PACIFIC GAS AND ELECTRIC COMPANY

2022 WILDFIRE MITIGATION PLAN UPDATE

ATTACHMENT 2

Table PG&E-4.6-2 Attachment

FIGURE PG&E-5.1.B-X:
MODEL DEVELOPMENT SCHEDULE

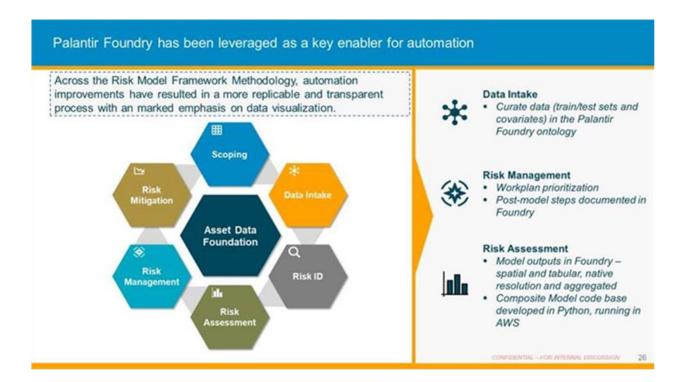
Issue: In the Maturity Model, PG&E self-reported a low score in risk modeling automation, with slower growth than its peer utilities.[1] PG&E overhauled its modeling efforts between the 2020 and 2021 WMP submissions. However, PG&E fails to demonstrate growth at a rate comparable to its peers in its risk modeling automation

- *Remedy (#1): PG&E must explain why it does not have the same level of automation for risk modeling as its peers, including an explanation of any constraints on progress; and.*

- *Remedy (#2): PG&E must supply a workplan and schedule for enhancing its automation capabilities in its risk modeling.*

- **Remedy #2**: As indicated in the response to Remedy #1 above, PG&E has implemented a workplan to improve the automation of our risk modeling capabilities. As indicated in the model development schedule shown below in FIGURE-PG&E-5.1.B-X will continue to automate the new features that are planned in future years as our risk models evolve.
